**PLAINVIEW PLANNING COMMISSION MEETING  
AGENDA**

# PLAINVIEW CITY COUNCIL ACTION

**Date:** July 7, 2022 – *Updated July 19, 2022*  
**To:** City of Plainview Planning Commission  
**From:** Harry Davis, AICP  
Brian Malm, P.E.  
**Subject:** Skye View Development Special District  
City of Plainview

**EXHIBIT B  
 CONCEPT PLAN**

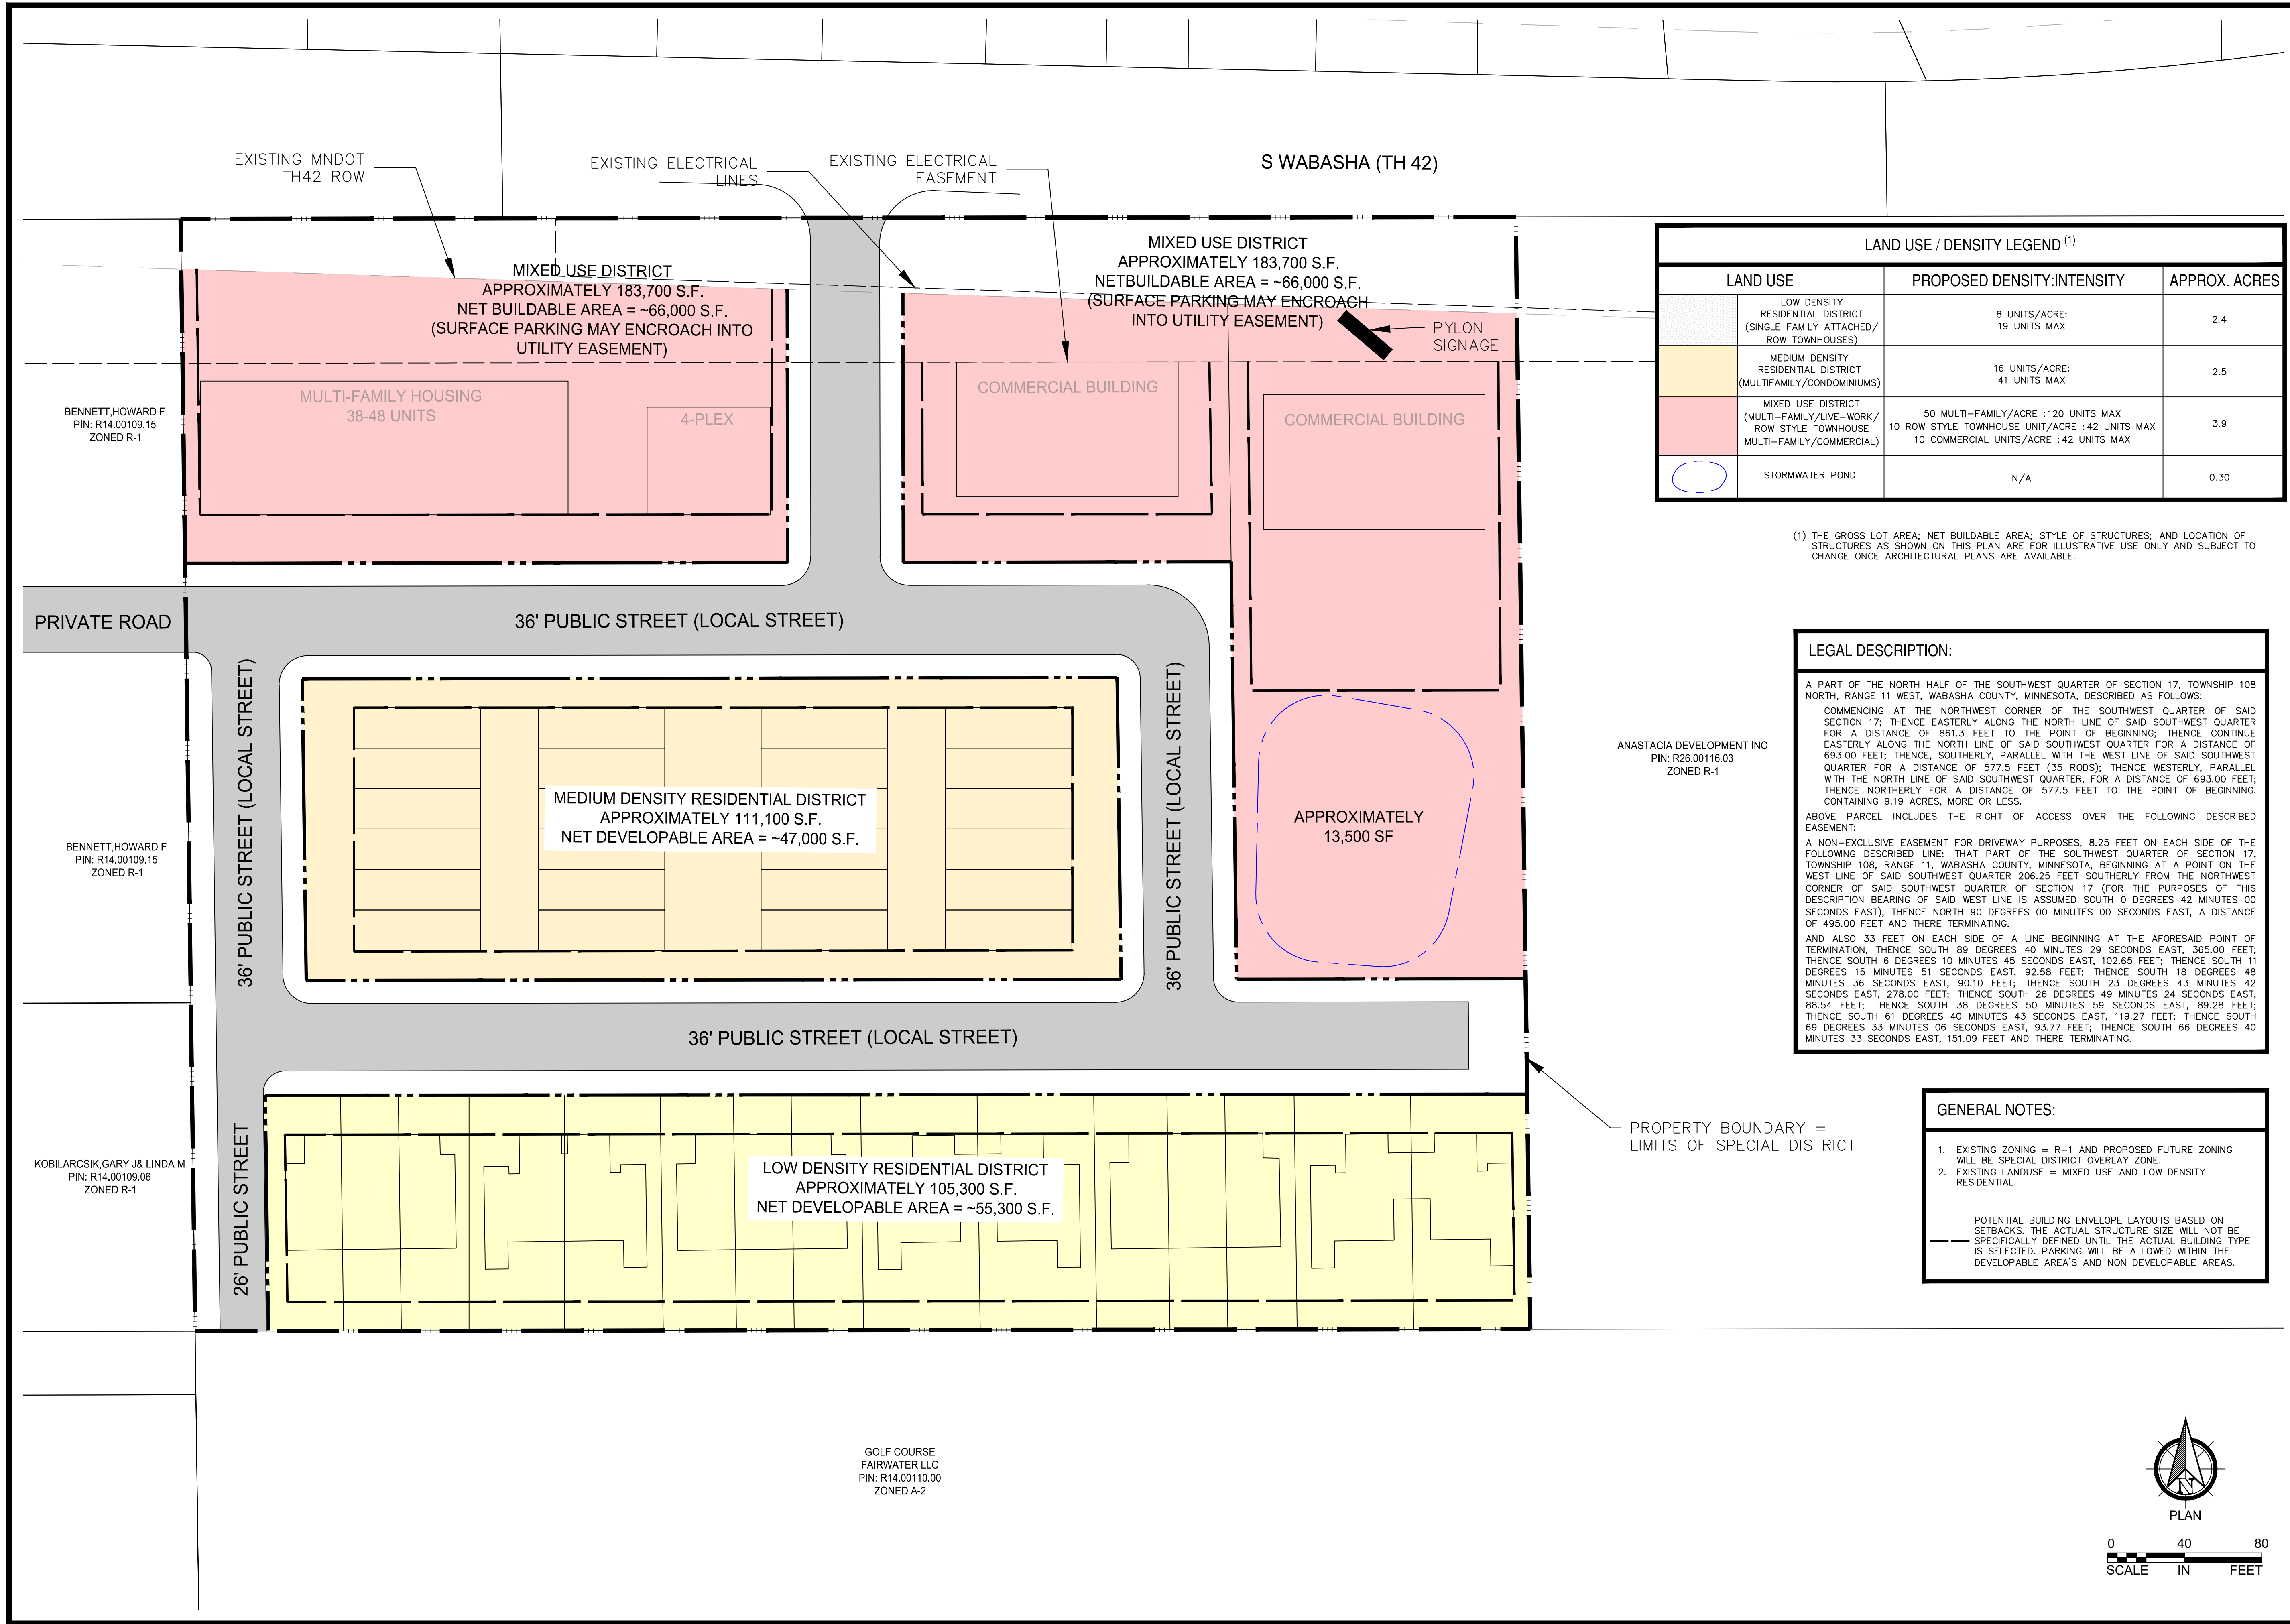
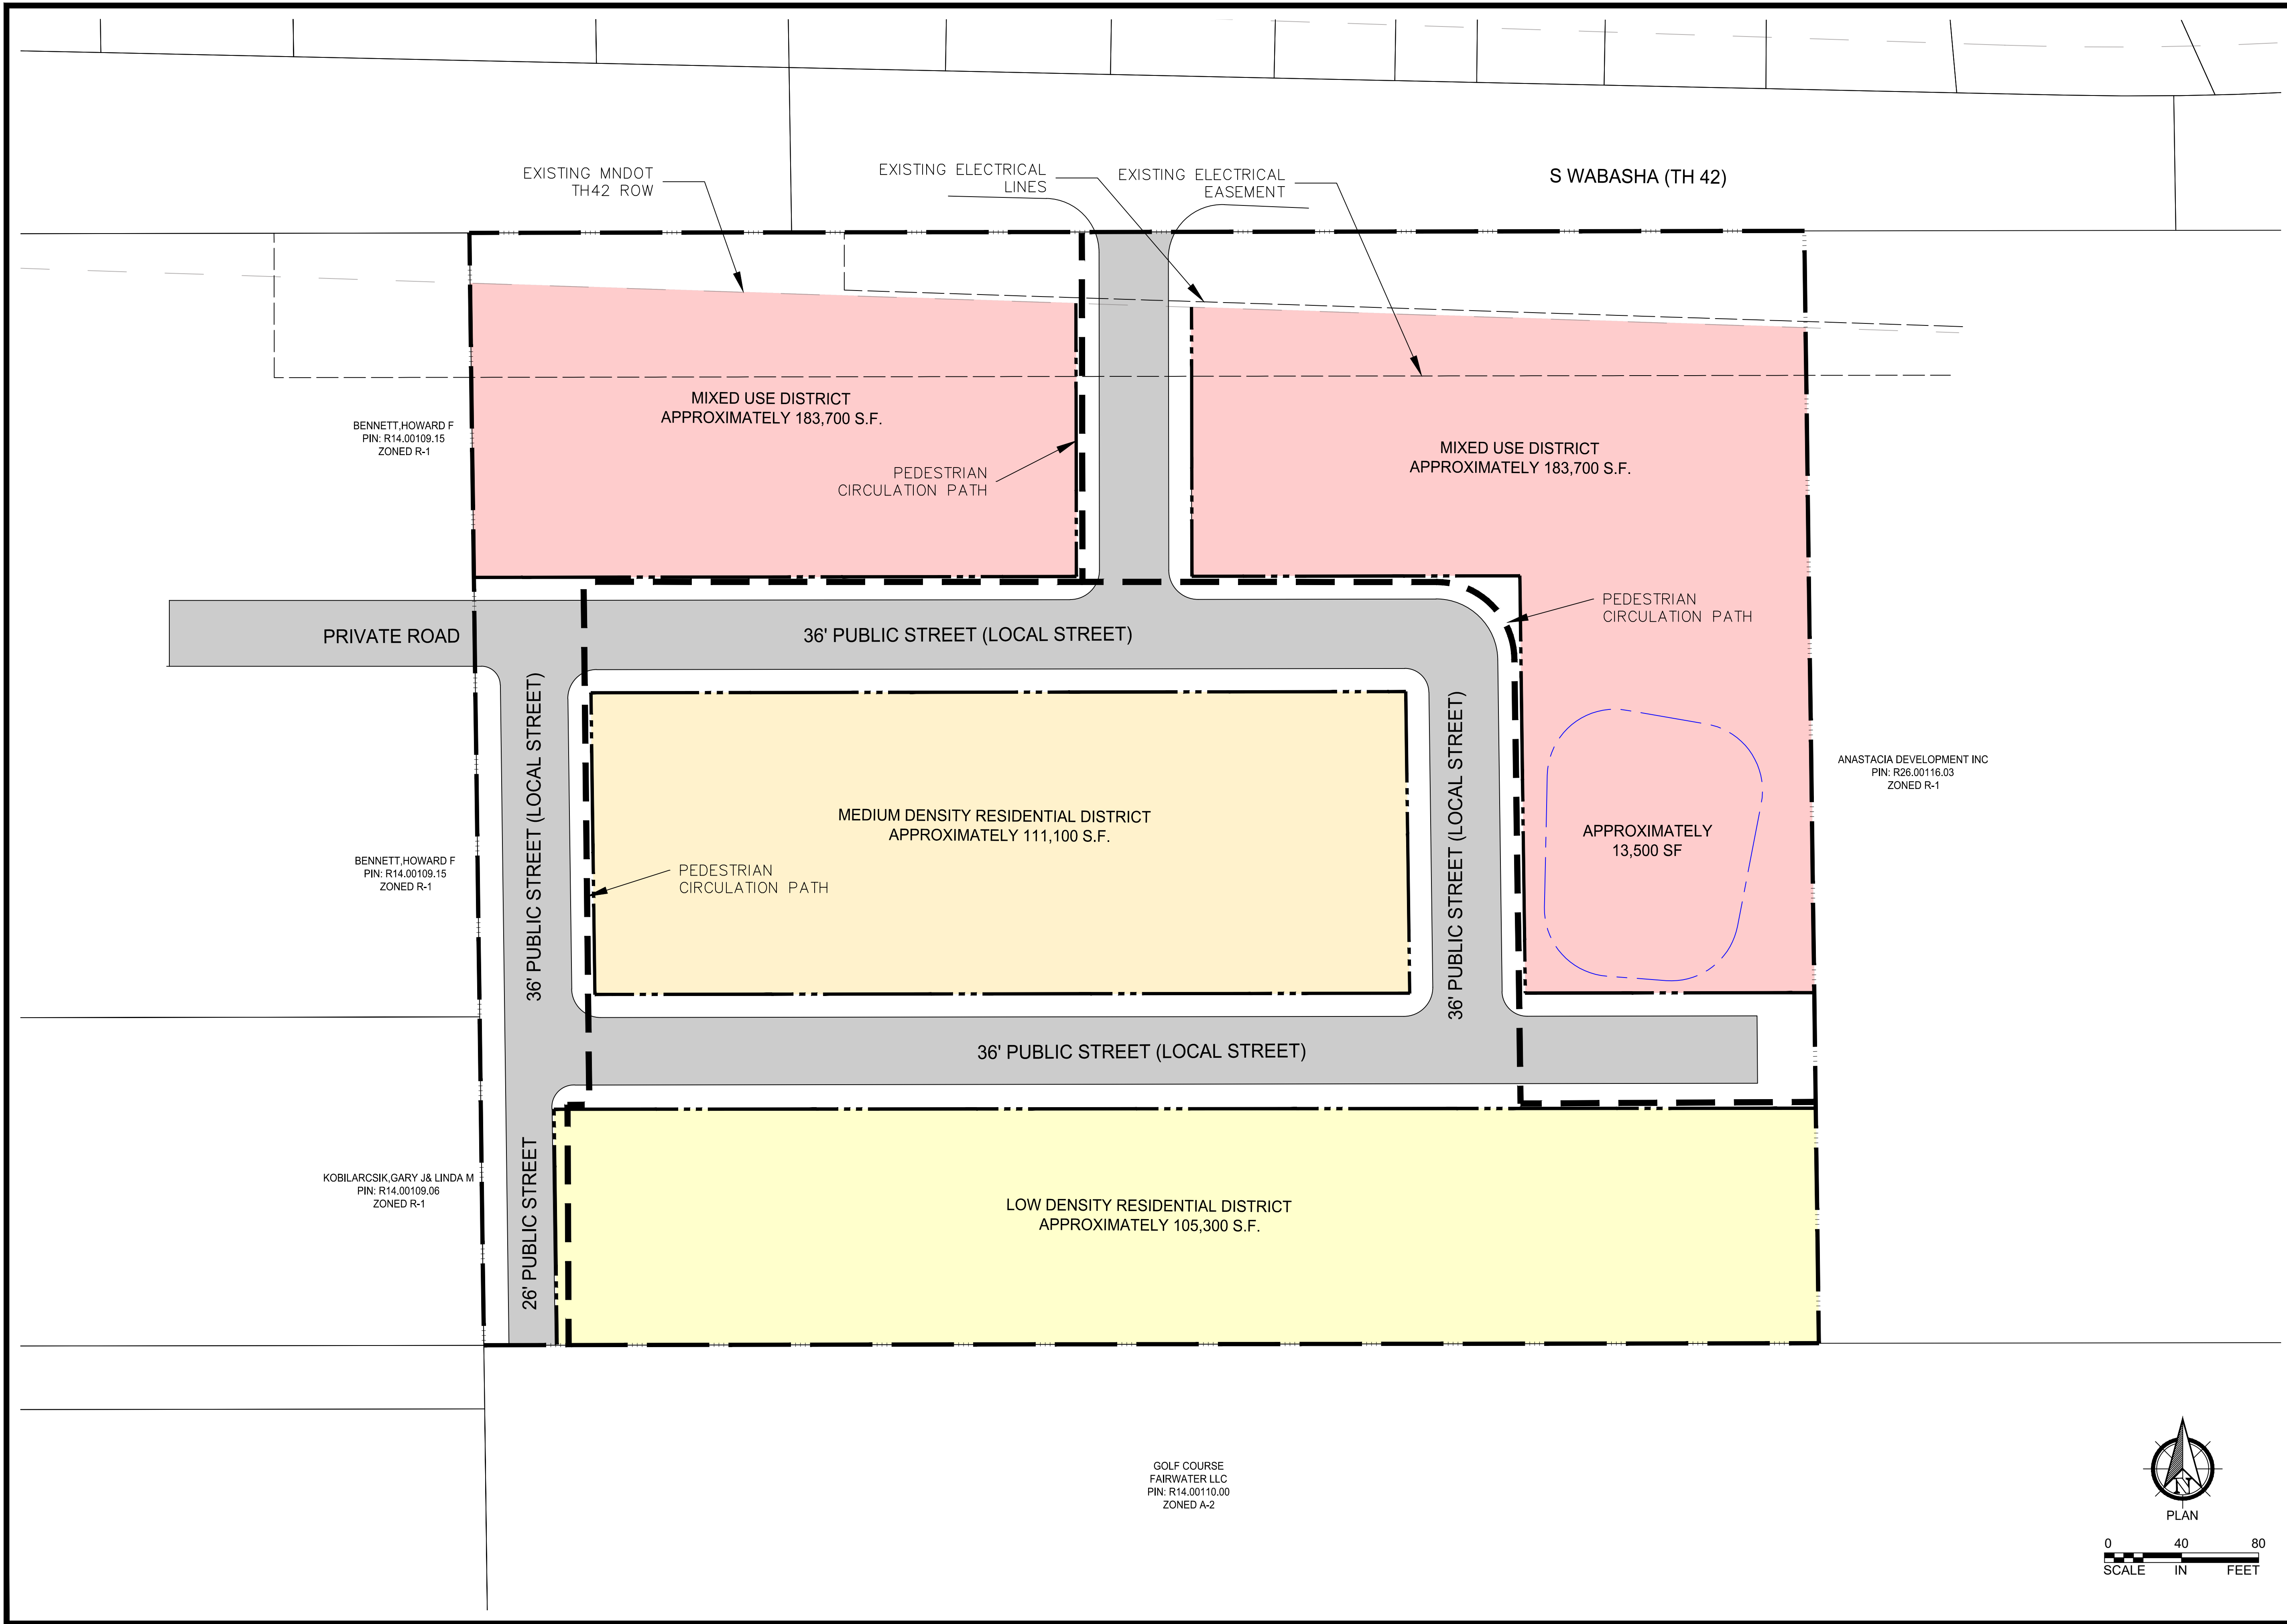
1. Exhibits B, C, and D show a 26-ft public street extension in the SW corner of the development within a 38-ft right-of-way and sidewalk within a 10-ft easement. This should be revised to show a 50-ft right-of-way with the street and sidewalk entirely contained within the right-of-way.
2. The proposed street connection to TH 42 shall be formally approved by MnDOT, prior to approval of the final plat.
3. The final plat (or plats, if the proposed subdivision is phased) shall avoid conflicts with existing underlying access easements.
4. Exhibit C shows proposed City utilities and street typical sections. Final approval of city street and utility layout, design, and details shall be based on final engineering plans, as approved by the City Engineer and other appropriate regulatory agencies, and may vary from what is shown on Exhibit C.

1. Exhibits B, C, and D shall be amended to show a 26-ft public street extension in the SW corner of the development within a 50-ft right-of-way with the street and sidewalk entirely contained within the right-of-way.
2. The proposed street connection to TH 42 shall be formally approved by MnDOT, prior to approval of the final plat.
3. The final plat (or plats, if the proposed subdivision is phased) shall avoid conflicts with existing underlying access easements.
4. Proposed City utilities and typical street sections shown in Exhibit C shall be subject to final approval by the City Engineer and other appropriate regulatory agencies, and may vary from final engineering plans.
